Access Compliance Report

Public Rights-of-Way

(Curb Ramps)

Intersection ID: 2805	Main Street: GLEN_MANOR_DR	Cross Street: GLEN_ROYAL_DR	Location: E
ADA ID: 123642860684	Ramp Type: Perp	Initial Pass/Fail: Fail	Overall Compliance: No
Severity Score: 58.75			
Codes/Mitigation Info/Possible Solution		Field Measurements/Component Compliance

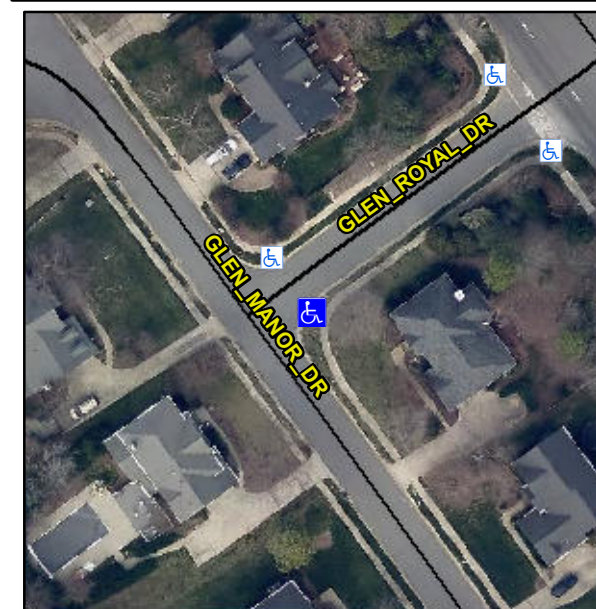
Not Found, R304.5.1, R304.2.2, R304.5.3

Compliance	Description	Data	Compliance	Description	Data
N/A	Ramp Length (in)	83.0	No	Ramp Slope (%)	12.4
No	Ramp Width (in)	38.5	No	Ramp XSlope (%)	8.1
N/A	Flare Type LT	N/A	N/A	Flare Type RT	N/A
N/A	Flare Slope LT (%)	N/A	N/A	Flare Slope RT (%)	N/A
N/A	Flare Traversable LT?	N/A	N/A	Flare Traversable RT?	N/A
N/A	Landing Length (in)	N/A	N/A	DWS Provided?	N/A
N/A	Landing Width (in)	N/A	N/A	DWS Contrast?	N/A
N/A	Landing Slope (%)	N/A	N/A	DWS Length (in)	N/A
N/A	Landing X Slope (%)	N/A	N/A	DWS Full Width?	N/A
N/A	Landing Curb? (Y/N)	N/A	N/A	DWS Offset (in)	N/A
N/A	Shared Landing?	N/A			
N/A	Gutter Ponding?	N/A	N/A	Gutter Slope (%)	N/A
N/A	Gutter Lip Ht (in)	N/A	N/A	Gutter X Slope (%)	N/A
N/A	Painted X Walk1?	No	N/A	Painted X Walk2?	N/A
	X Walk 1 Direction	To NW		X Walk 2 Direction	N/A
N/A	X Walk 1 Width (in)	N/A	N/A	X Walk 2 Width (in)	N/A
	X Walk 1 Slope (%)	0.6		X Walk 2 Slope (%)	N/A
	X Walk 1 X Slope (%)	4.9		X Walk 2 X Slope (%)	N/A

Remove & Replace Entire Ramp.
